Addendum No. Three

Date: August 5, 2020
Project: Floquip Drainage Project, MES No. 2020-14
Engineer: M.E. Sack Engineering
Hinesville, Georgia

C101

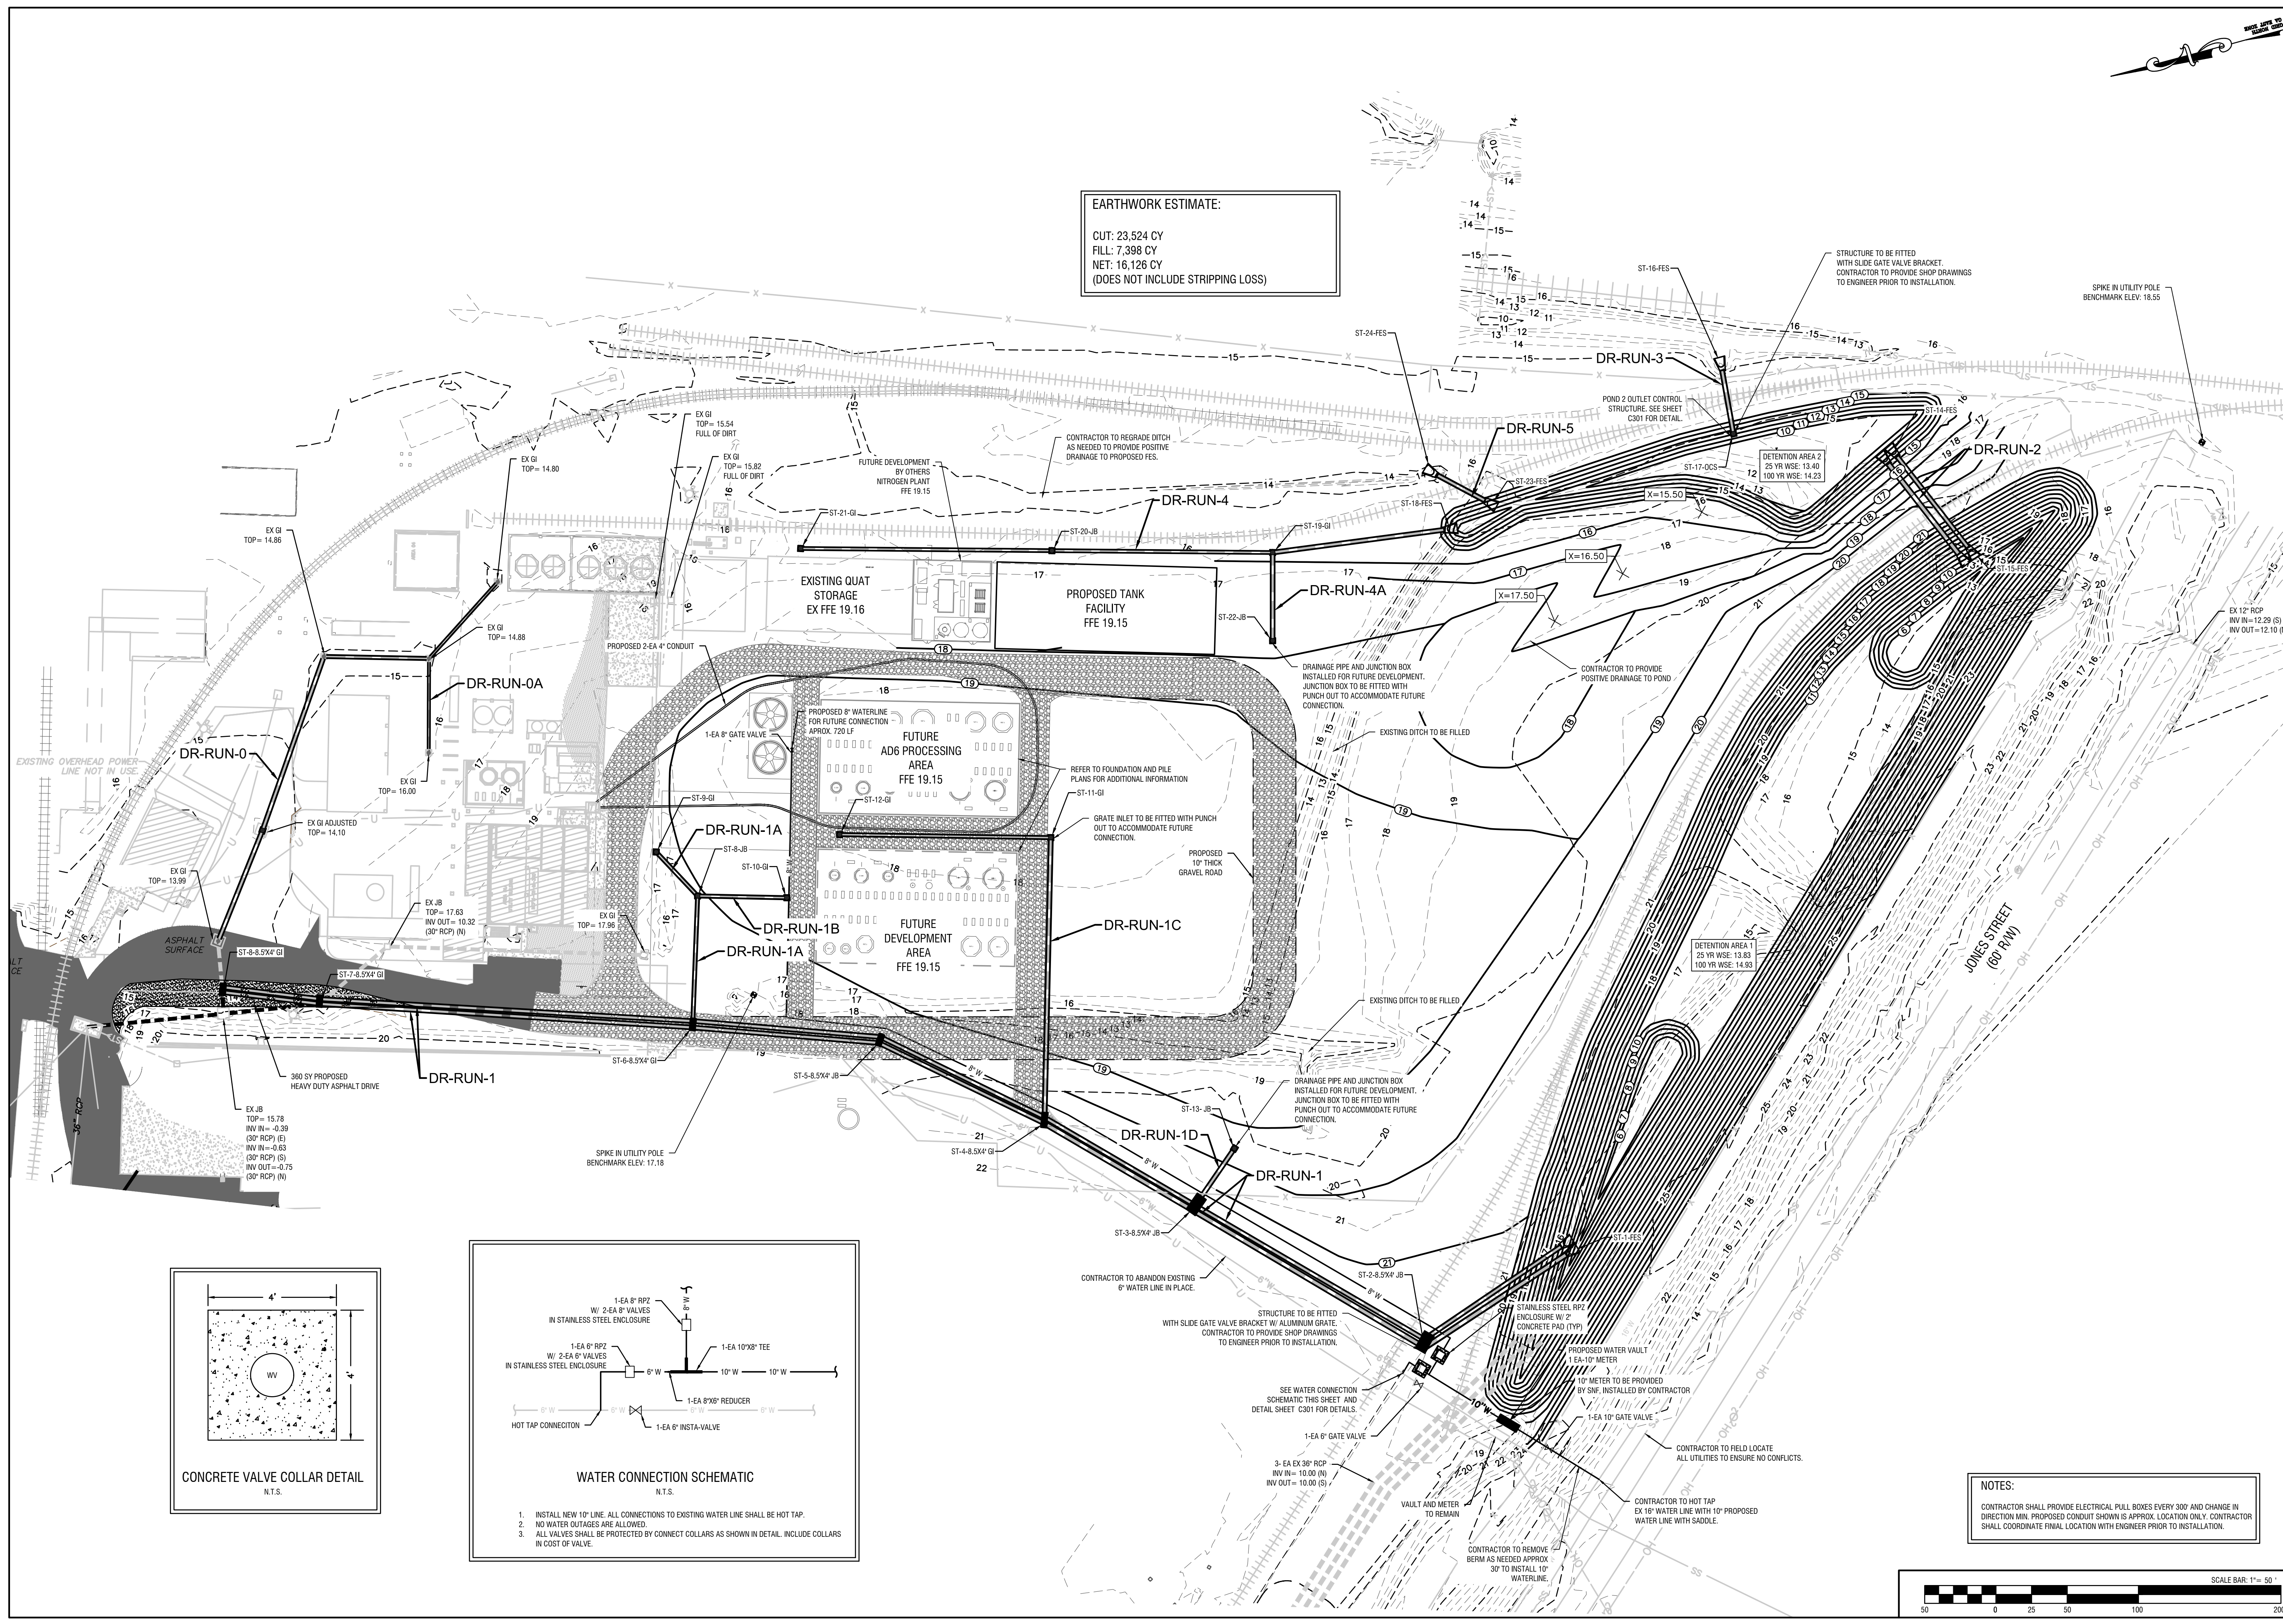
- Replace sheets C101 and C200-C202 of the original plans. Note berm removal was included on sheet C101 for installation of 10" water line.
 - Chain Link fence and gate was added to sheets C200-202 at the end of asphalt drive.
 - Orange Safety Fence was delineated around perimeter of construction site.
 - NAVD88 was removed from Sheet C101 for clarity.
